PCI-SIG ENGINEERING CHANGE NOTICE

TITLE:	Dynamic Power Allocation
DATE:	May 24, 2008
AFFECTED DOCUMENT:	PCI Express Base Specification version 2.0
SPONSOR:	Intel Corporation, Hewlett-Packard, IBM

Figure 7-xx Dynamic Power Allocation Capability Structure

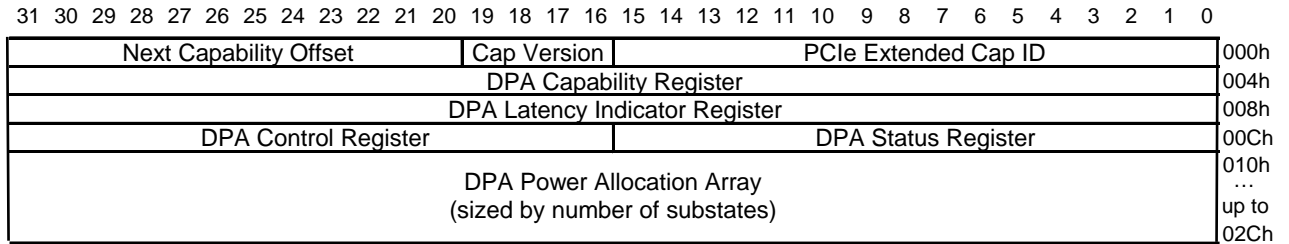
The DPA Capability structure is shown in Figure 7-xx below

Figure 7-xx DPA Power Allocation Array

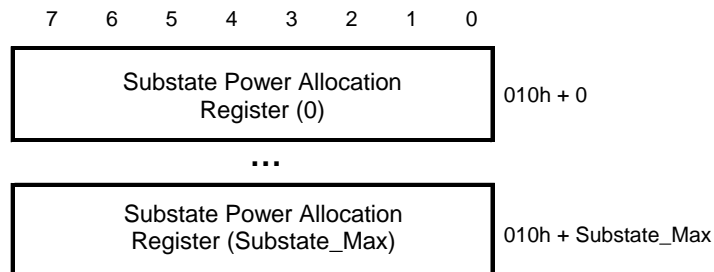
Each Substate Power Allocation Register indicates the power allocation value for its associated substate. The number of Substate Power Allocation Registers implemented must be equal to the number of substates supported by Function, which is Substate_Max plus one.

<u>Bit Location</u>	<u>Register Description</u>	<u>Attributes</u>
<u>7:0</u>	<p>Substate Power Allocation: The value in this field is multiplied by the Power Allocation Scale to determine power allocation in Watts for the associated substate.</p>	<u>RO</u>
